#### 24 Griffin Street

**EXISTING FRONT ENTRANCE**

#### Appendix "C" to Report PED22072 Page 1 of 6

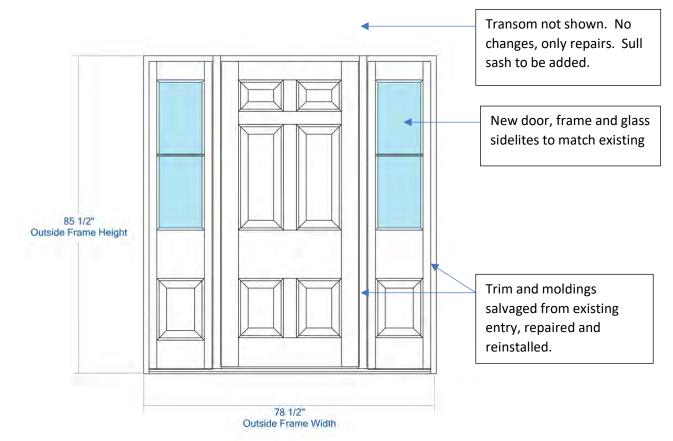
At some point the hinge position has been changed. Wood is rotten and will not hold a screw. New location below tenon is weak. Propose new 1 ½ pr hinges in lieu of 1 pr existing.

Install new frame, door, hardware and weatherstripping. Salvage and reuse all trim and moldings.

Transom to be repaired. Trim and moldings to be salvaged and reused. Sull sash to be added.

Door sidelite glass to be replaced with double pane sealed glass unit, same size, same mid divider.

Insulated panels to be added below glass in the side lites. Wood panels to be repaired and reused.

Wood frame around entrance to be repaired and maintained.
